Insufficient Heating Output Due To Broken Refrigerant Line Between Refrigerant Compressor And The condenser (Hot Gas Line)

Topic number	LI83.20-P-076623
Version	3
Function group	83.20 - Heating
Date	10/6/25
Validity	EQA (H243), EQB (X243)
Reason for change	Remedy

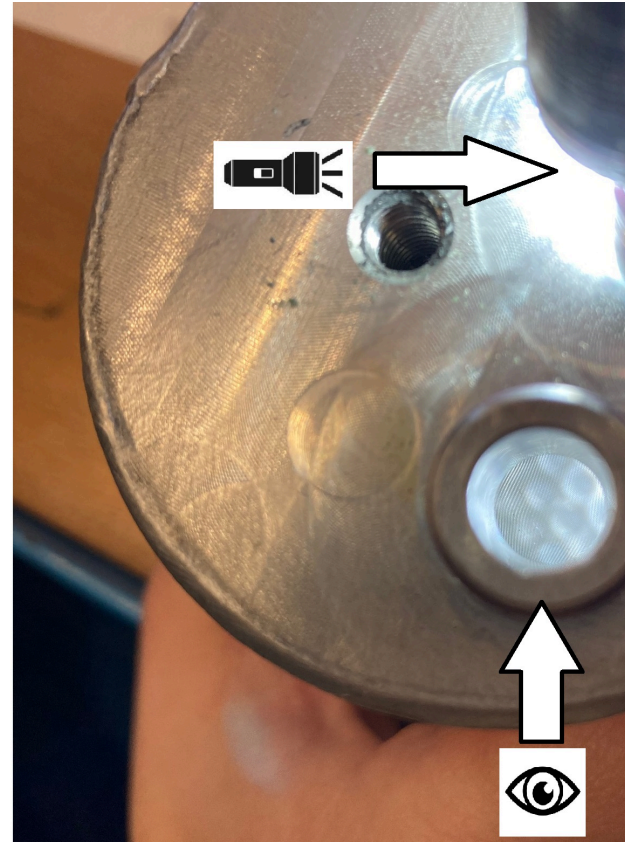
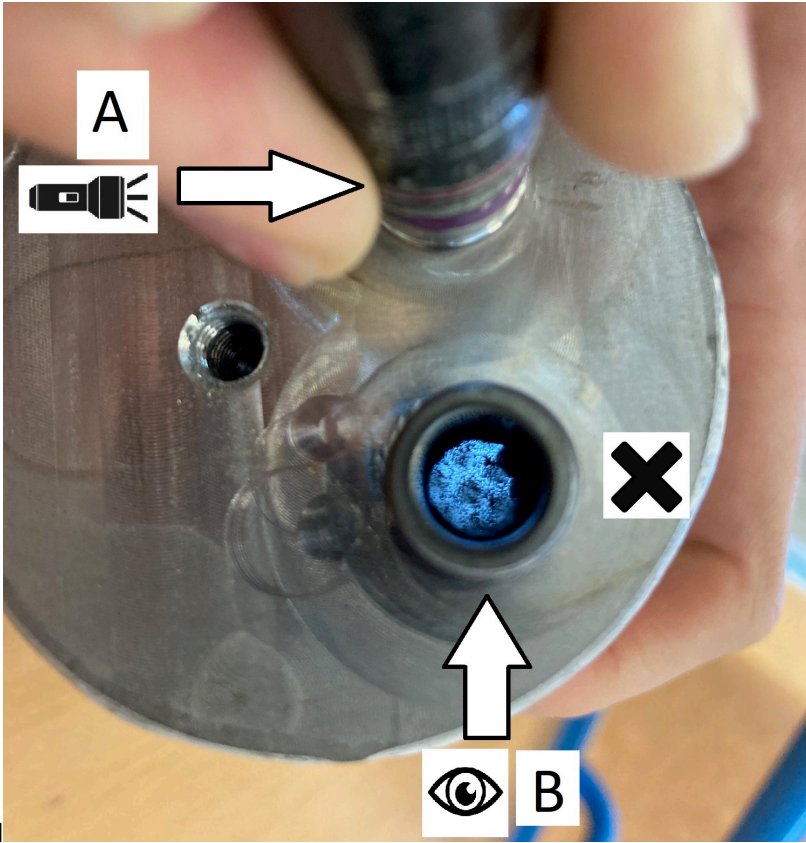
2. Check dryer cartridge at condenser for particles: Remove dryer cartridge, illuminate inlet of dryer cartridge using flashlight (A), and examine filter screen through outlet of dryer cartridge (B) -> see comparison picture bad/good

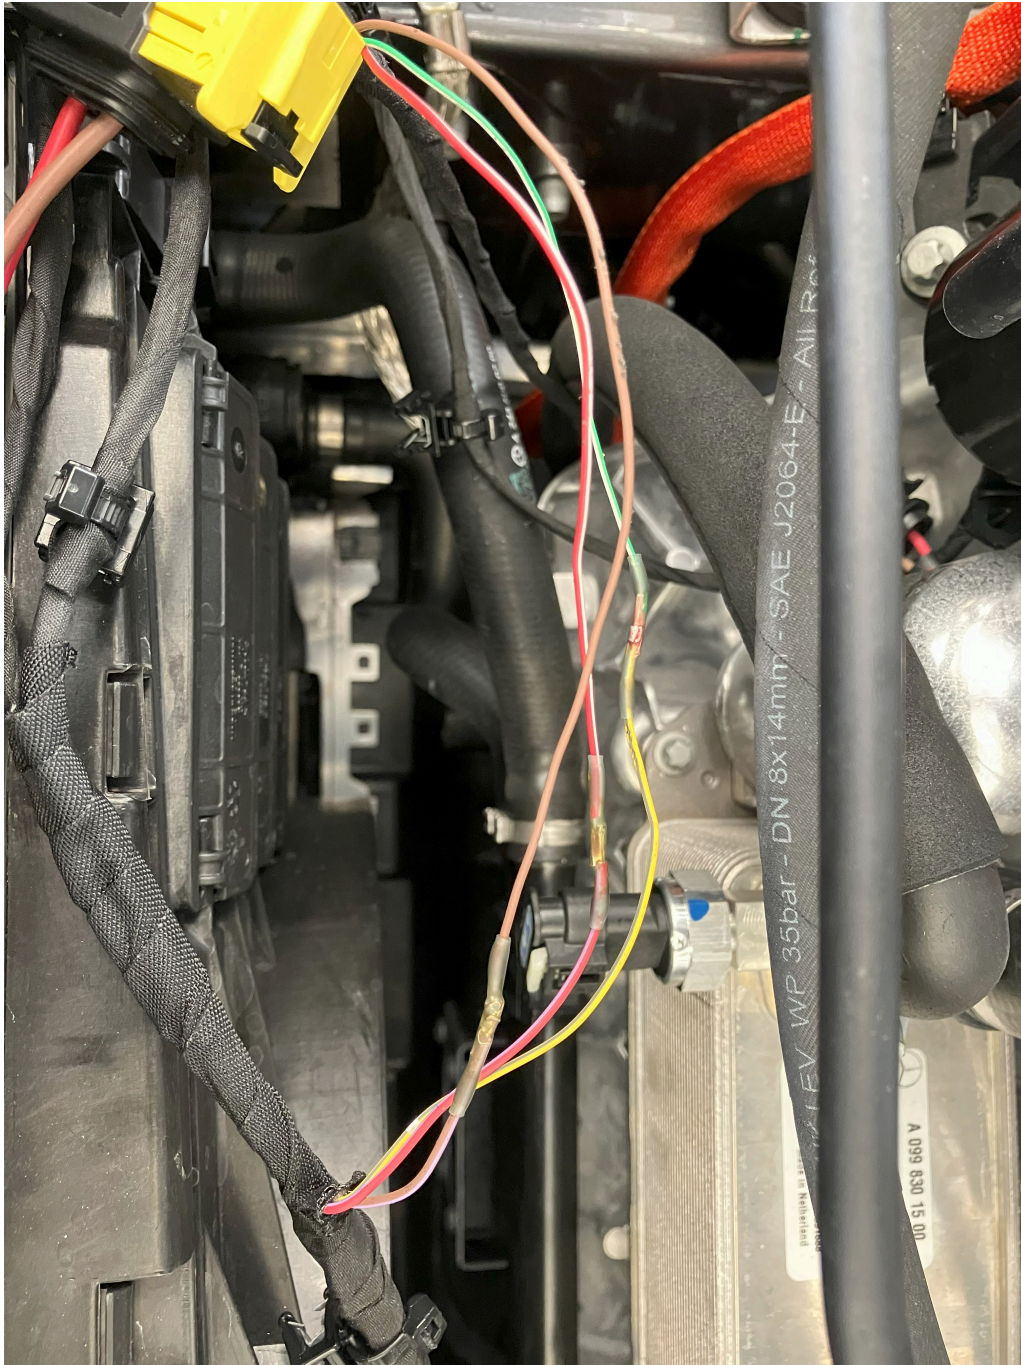
33. In order to use the new refrigerant line A2438308600, the electrical wire of pressure sensor B161/2 must be extended.

- Disconnect plug from pT sensor.
- Remove insulation approx. 15 cm from the plug.
- Extend lines by 425 mm. For this purpose, please observe the Basic data for wiring harness repairs with axial solder connectors (AR54.18-P-0100-06A).
- Wrap wiring harness with complete insulation wrapping.
- Route wire to the newly positioned pT sensor and secure with cable tie to prevent scouring.
